241–244 PENNANT HILLS ROAD, CARLINGFORD

RTS MATRIX – KAA RESPONSE

MAY 26, 2026

This report has been prepared by Kennedy Associates Architects to address and respond to the urban design and architectural issues set out in the DPHI Letters of 5 & 26 February 2026 and Parramatta City Council submission dated 3 February 2026 for the proposed development at 241-244 Pennant Hills Road, Carlingford – SSDA No 84699461.

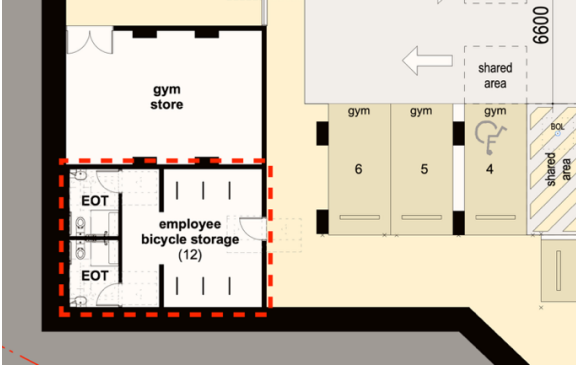
2b	DPHI	Review the proposed building and basement setbacks from the 'developable site area' boundaries to Pennant Hills Road and the corner which extends around to Felton Road, noting that there is limited opportunity for landscaping in these prominent areas after any future road widening occurs. Increased setbacks should be provided from the future boundary, including deep soil and tree planting, to contribute to the landscaped character of the area and mitigate the visual impacts of the proposal from the public domain.	Building A has been reworked to provide a minimum 6m setback to Pennant Hills Road as measured from the 'developable site area'.  Figure 2b.1: Amended Typical floor plans with overlay of footprint from original DA submission shown dashed in purple. The basement footprint has been reduced with increased setbacks of between 4.5 - 6m to Pennant Hills Road with external walls of the basement amended to align with the edges of hard paved areas above.

The figure is a detailed architectural plan of a basement level. It shows various rooms, corridors, and structural elements. A solid black line outlines the current 'Amended Basement 01' footprint. A dashed yellow line shows the 'basement footprint (original SSDA submission)'. The plan includes dimensions such as 2.5m, 3.1m, and 2.2m, indicating specific setbacks or clearances. The layout is complex, with multiple rooms and a central corridor system.
2c	DPHI	The landscaping proposed within the area identified for future road widening must be excluded from landscaping calculations. Landscaping of the road widening area is beneficial from a visual perspective until such time as the widening occurs, however is not part of the developable site area and cannot be relied upon long - term. Additional plans are required detailing the landscaping from the 'developable site area' boundary after road widening with no landscaping shown external to the site to clearly see the landscaping within the site.	The amended plans demonstrate compliance with the Housing SEPP with a landscape area of 47.5% relative to the 'developable site area' (exceeding the 30% minimum landscape require under the Housing SEPP)

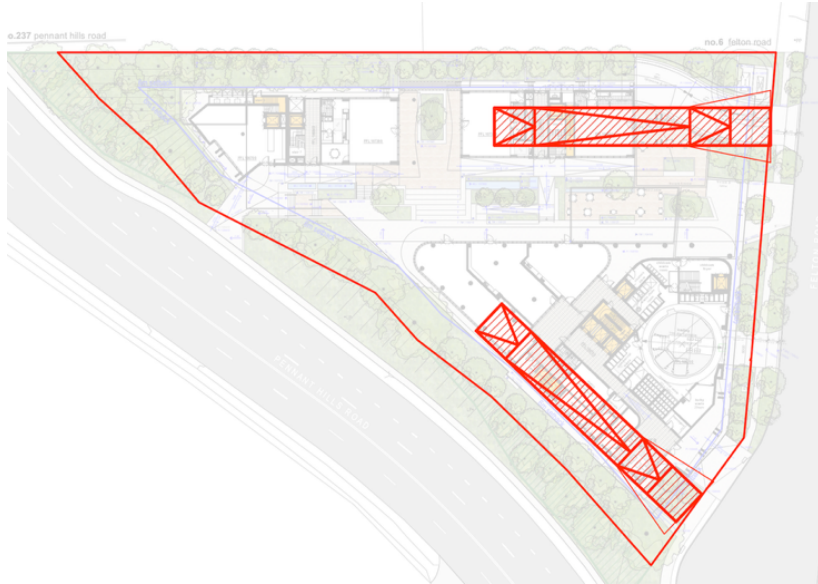
3d	DPHI	Provide end of trip facilities for the commercial and retail users.	End of trip facilities have been provided in the southern end of Basement Level 01  <i>Figure 3d.1: Basement 01 Plan Detail indicating EOT facilities</i>
3e	DPHI	Provide EV charging for the commercial and retail users.	10 - 20% of commercial, gym and parking spaces will be capable of being fitted with EV charging devices in accordance with the NCC.
3f	DPHI	Detail how the proposed three and managed appropriately for use by all residents. EV spaces for the residential spaces are sufficient in quantum.	All residential parking spaces will be capable of being fitted if EV charging devices in accordance with the NCC.

Figure 4-b.3: Building B & C waste bin carting route in Basement 1

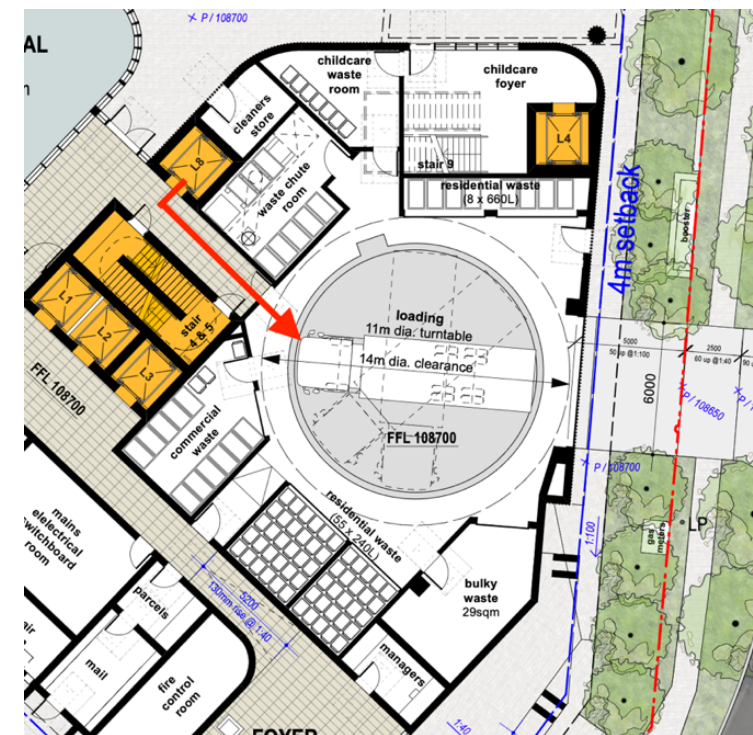
4b	DPHI	The proposed waste management arrangements indicate that building manager/caretaker is responsible for moving the waste bins from Buildings B and C on the western side of the site to the collection area in Building A. Appendix B of the WMP indicates the path of travel for commercial via the pedestrian site link/ central forecourt, however the WMP does not indicate: - residential movements from Buildings B and C on the western side of the site to the collection area in Building A. - what time of day these movements from Buildings B and C on the western side of the site to the collection area in Building A will occur, nor the frequency. The number of movements of bins through the central forecourt should be limited, as well as the time of day, to ensure that it occurs at a suitable time where there will be minimal pedestrian conflict whilst adhering the noise management measures.	Within Buildings B & C, each commercial tenancy is provided with its own bin storage area whilst residential units are provided with bin rooms on each level. The movement of bins to the bin collection area will be done by Building Management. The design has been amended to enable commercial and residential waste in Buildings B and C to be taken down to Basement Level 1 (via Lifts 5, 6 and 7) and then taken across to Lift 8 and carried up to the waste and loading areas on the ground level of Building A. A bin tug storage location has been provided in Basement Level 1. Figure 4-b.1: BLD B commercial waste carting route to Lift 5 Figure 4-b.2: BLD C commercial waste carting route to Lifts 6&7

Figure C-8.2: Felton Road Elevation massing diagram

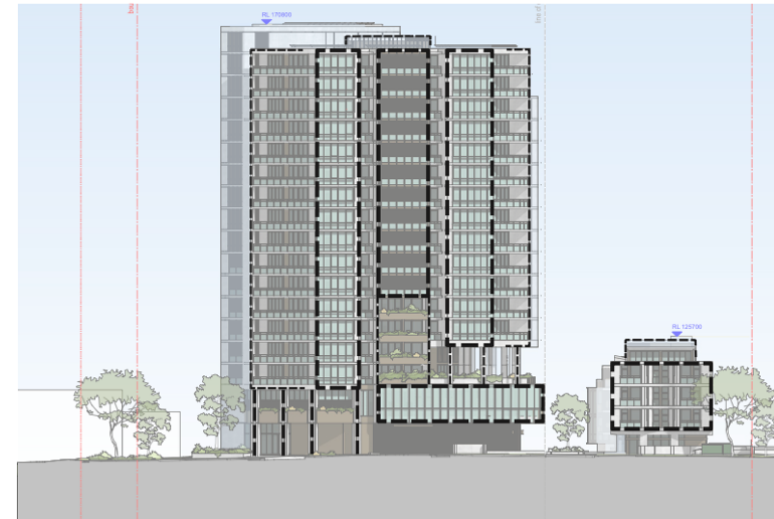
C-8	CoPC	Built Form and Massing (Building A) The overall composition of the building is highly complex, with multiple projecting elements, deep recesses, undercroft spaces and competing geometries that result in a visually busy and convoluted built form. The lack of a clear massing hierarchy makes the building appear heavier and more fragmented than necessary. The tower does not exhibit the qualities associated with good high-rise proportioning, where the built form is typically arranged as a tall, slender element with a compact floorplate and a coherent vertical expression. Instead, the proposed tower reads as a wide, solid volume with an expansive floorplate that gives it a broad and heavy profile, intensifying its perceived bulk from both Pennant Hills Road and Felton Road. A more refined architectural approach would consolidate the tower into a leaner, more vertically oriented form with reduced horizontal spread, allowing for improved skyline proportion and reduced perception from distant views. Greater setbacks and landscape integration for the podium would also provide a more human scale pedestrian interface and an improved microclimate. The tower width dimension is significantly greater than what would be expected for a well-proportioned tower in this location (60m width along Pennant Hills Road is proposed). A more appropriate length, based on established urban design principles for tall building proportion and the earlier iterations and plans for this precinct, would be in the order of 45 metres. Reducing the tower's horizontal extent, or introducing substantial recesses and vertical breaks, would help achieve a more balanced massing outcome and soften its presence in the broader landscape.	The design of Building A, the tower building, addresses the complex character of its triangular site in a careful and innovative manner. The building expresses the triangular form created by Pennant Hills Road, Felton Street and the Through Site Link directly in a building composed of three discrete elements rotating around a triangular central core. This enables the building to have individual and unique facades fronting all three 'streets'. The three facades are separated by 'breaks' (deep recesses) which open the building on the corners, articulating the individual elements and creating transparency. Each frontage is then further articulated by three vertical elements, separated by recessed balconies, emphasising verticality through form, depth, shadow and material; and balancing the tower form with the horizontal ribbon of the podium. That is, the building's program evolves out of its site specific geometry which becomes the generating theme for the building. • three frontages • three facades • three residential units per façade • three vertical elements within each facade With the exception of the corner of the building at the junction of Pennant Hills Road and Felton Road, the podium forms a ribbon wrapping and enclosing the lower levels and then turning up in the centre of the Pennant Hills Road and Felton Road frontages. This is a classic modelling approach in contemporary architecture. The building comes to the ground on the corner of Pennant Hills Road and Felton Road to express entry and ground the building as it addresses Carlingford Town Centre.

Elsewhere, the building is set on 'legs' which lift it off the podium lightening its appearance.

Verticality is further emphasised by the use of, columns, materiality, glazing and articulation.

Each facade is then specific to its particular orientation.

The Pennant Hills Road façade is more 'closed' through the use of winter gardens to address street noise, whilst the Northern and Western Facade utilise slab edges and screening to address solar impacts.

Figure C-22.1: Typical Outdoor Play Space Façade Details indicating ventilation, acoustic and climability requirements.

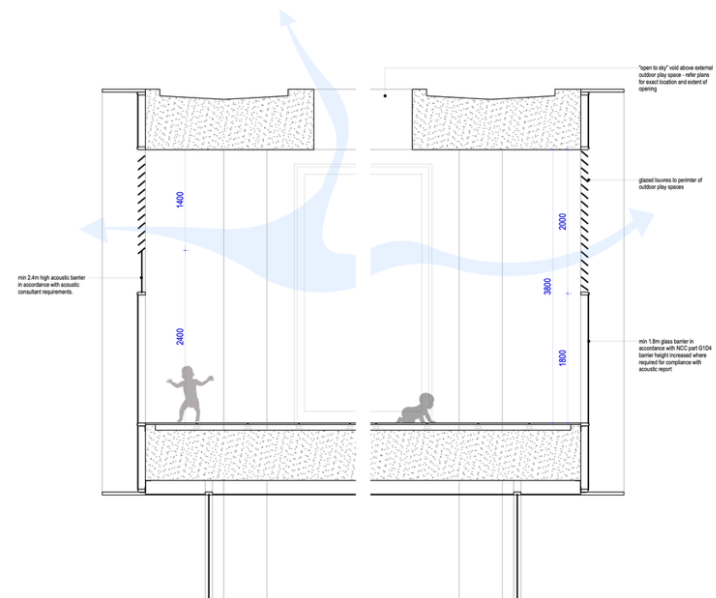
Gross Floor Area Calculations			
C-22	CoPC	Upon review of the gross floor area calculations provided by the proponent, it is evident that the total gross floor area of the proposed development has been incorrectly calculated. In summary, the applicant has calculated a total floorspace of 15,738sqm (16,203sqm including 465sqm winter garden allowance) whilst Council calculates a total of floorspace of 16,722.7sqm (17,187.7sqm including 465sqm winter garden allowance). REFER LETTER FOR FULL DETAILS & TABLE.... There are numerous areas within the gross floor area calculations provided by the proponent that have been incorrectly excluded. A summary of these areas is provided in the following table. As identified above, a total of 1,007.7sqm of additional floor space may be counted toward gross floor area under the statutory definition of the Parramatta Local Environmental Plan 2023. The proposal therefore likely exceeds the maximum floor space ratio permitted under the Parramatta Local Environmental Plan 2023 and State Environmental Planning Policy (Housing) 2021. As no clause 4.6 variation request accompanies the application, the application can only be determined by way of refusal.	Council's concerns regarding the gross floor area (GFA) calculations are noted. Updated GFA calculations have been provided with the amended scheme, which incorporate areas identified in Council's table, including waste storage areas. Consistent with the original DA submission, the childcare outdoor play areas are excluded from GFA. Council has argued that these areas should be included on the basis that perimeter walls exceed 1.4m in height, however it is common and necessary practice in Child Care Centres for perimeter barriers to exceed 1.4m in outdoor play areas to address safety, acoustic and fall prevention requirements. For example, the NCC requires 1.8m high barriers to outdoor play spaces more than 2m above ground level. This does not, in itself, result in the 'outdoor' areas meeting the definition of GFA. In this instance, each of the outdoor play areas incorporates a number of non-weather protected openings including a fully open void space to sky. That is they are 'external' areas which are not fully enclosed and are, in part, open to the sky. This approach to GFA is supported by established case law. In C & J Corporation Pty Ltd v Canterbury-Bankstown Council, the Court accepted partially enclosed and partially roofed outdoor play areas as not forming part of Gross Floor Area. Similarly, in Bright Beginnings v Bayside Council, the Court accepted a covered upper-level outdoor terrace substantially enclosed by full-height

walls and acoustic barriers, where the space still maintained a meaningful opening to air and external conditions.

In addition, the façade treatments have been developed to incorporate a combination of louvres and low level acoustically rated plenums to ensure these spaces are permanently naturally ventilated.

They provide open-air access, natural light and ventilation notwithstanding the necessary perimeter treatments required for safety, acoustic performance and compliance with NCC climbability requirements.

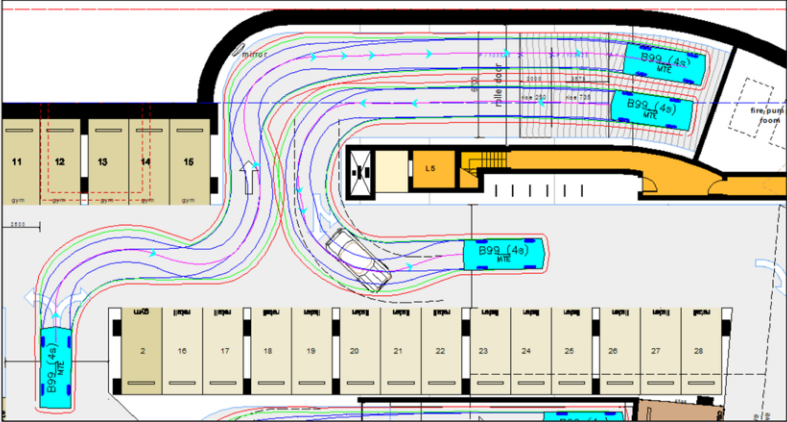
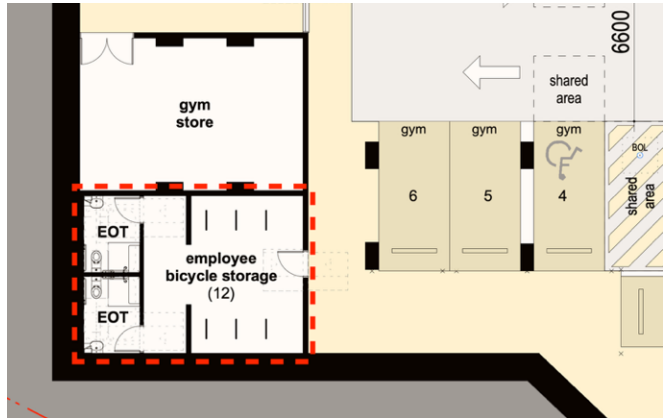
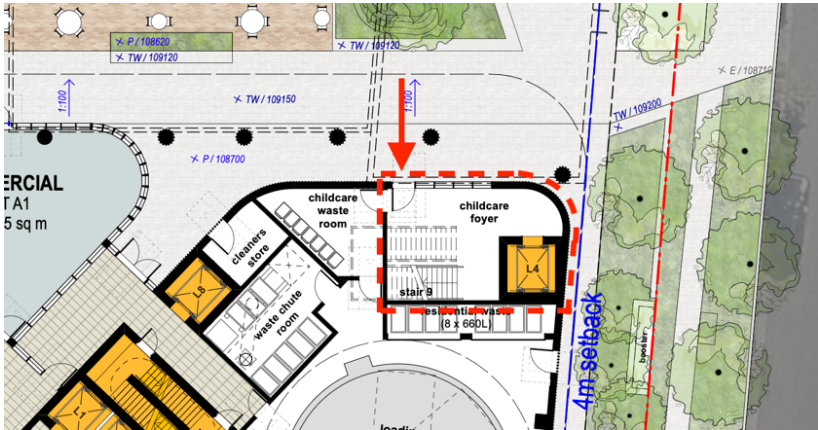
Based on the non-discretionary standards of the SEPP (Housing), the following parking rates are applicable for the residential component of the development:

In accordance with the table above, the development is required to provide a total of 166 residential parking spaces in order to meet the SEPP requirements. However, the development only provides 151 spaces resulting in a shortfall of 15 spaces. Furthermore, it is noted that for the non-affordable component, the shortfall is higher at 22 spaces.

Concern is raised over the significant shortfall in residential parking and its (likely) impacts on on-street parking in the surrounding area.

The contention that the proposal has an undersupply of parking is based on an incorrect assessment of the development yield and parking requirements.

In line with commentary from DPHI, the residential parking provisions have been reduced to comply with the maximum allowable spaces permitted under rates prescribed within the Chapter 2 of the Housing SEPP.

A total of 216 residential spaces has been provided, which comprises 17 AH spaces and 199 non AH spaces.

28 visitor spaces have been provided based on PDCP's rate of 0.2 / spaces per dwelling.

Figure C-37.2: Typical Outdoor Play Space Façade Details indicating ventilation, acoustic and climability requirements.

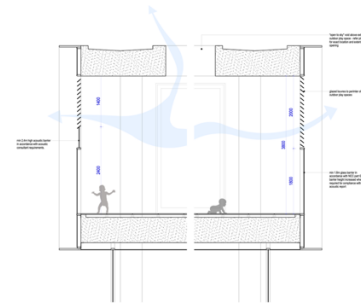
C-37	CoPC	Centre-Based Child Care Facilities – Outdoor Play Areas It is unclear whether the largely enclosed outdoor spaces meet the definition of “outdoor play area”. Information provided by Australian Children's Education and Care Quality Authority (ACECQA) on appropriate outdoor space states that "Enclosed, covered outdoor spaces that are not open to the air will not be considered part of the outdoor space without approval by the regulatory authority" (p. 3). Given that the outdoor spaces are enclosed on all sides by the outer walls of the building, with only small openings provided, it is considered unlikely that these spaces count toward unencumbered outdoor space requirements under the regulation. In the event that these spaces do not meet the relevant definition / requirements, the absence of suitable outdoor play space is considered to be a poor design outcome. Council would not support a facility of this scale that solely relies on simulated outdoor play. In addition, concern is raised over the fragmentation of the outdoor play areas. The fragmented spaces, combined with the provision of multiple columns within those spaces, will likely inhibit effective supervision of children. The outdoor play areas also present privacy conflicts with the nearby proposed terrace dwellings. Additional separation between the outdoor play areas and nearby dwellings is required, through the form of landscaping (or the like). Based on the above, Council recommends a significant redesign of the proposed Centre-Based Child Care Facility.	Council’s concern regarding the proposed outdoor play areas is noted. As noted in C22 above, each outdoor play space includes an area directly open to sky. In addition, the façade treatments have been developed to incorporate a combination of louvres and low level acoustically rated plenums to ensure these spaces are permanently naturally ventilated. For portions that are covered floor to ceiling height of 3.8m is proposed. As such, the spaces are considered to provide an appropriate outdoor environment for a contemporary child care. <i>Figure C-37.1: Diagram showing extent of open to sky voids above outdoor play spaces</i>
